PM5357

S/UNI-622-POS

**SATURN USER NETWORK INTERFACE
(622-POS)**

ERRATA

Power Supply Component Layout

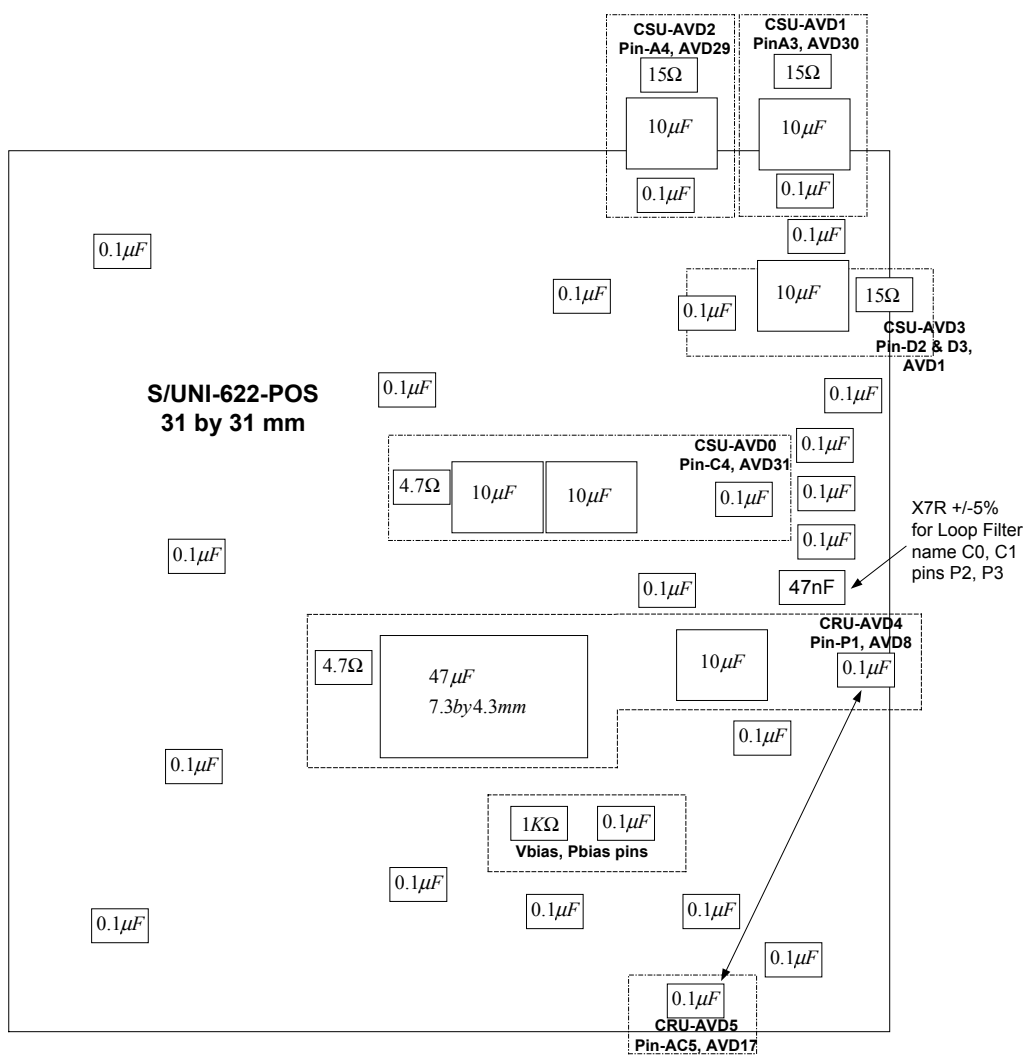
2.1 Power Supply Filtering Mechanical Drawing Incorrect (Pg. 339, Section 13.14)

The loop filter capacitor recommendation specifies a 47nF capacitor not a X7R 47uF capacitor as shown in the datasheet. The correct figure is shown below:
